Technical product information

Topic	Temperature Pop-Up No Longer Displayed in the MMI Display Continental GT/GTC /Flying Spur
Market area	Bentley: worldwide (2WBE),China 796 VW Import Comp. Ltd (Vico), Beijing (6796)
Brand	Bentley
Transaction No.	2080951/1
Level	EH
Status	Released for publication
Release date	Feb 23 2026

Figure 1. Temperature pop-up present in the MMI display

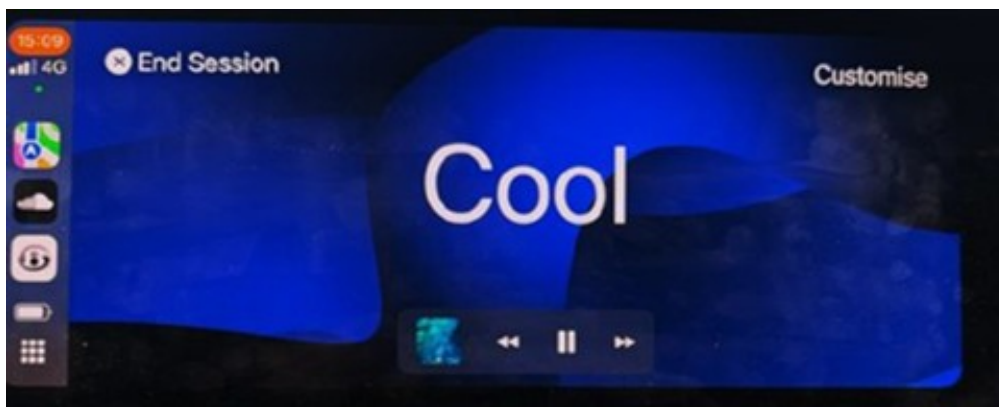
Customer query is verified that the temperature popup previously shown on temperature adjustment is no longer displayed. This behaviour matches the before and after images shown above. No relevant DTCs are stored.

Latest HVAC software update introduces robustness improvements for Auto On functionality. The update also intentionally removes the temperature popup display when the temperature is adjusted via the app or the rotary dial.

This new behaviour is by design and not an indication of a system fault.

- The removal of the temperature popup is intentional with the new HVAC software.
- The change forms part of the HVAC robustness improvements.
- This behaviour is correct and expected on vehicles updated to or built with latest Baseline Intergraton (BiL) software.
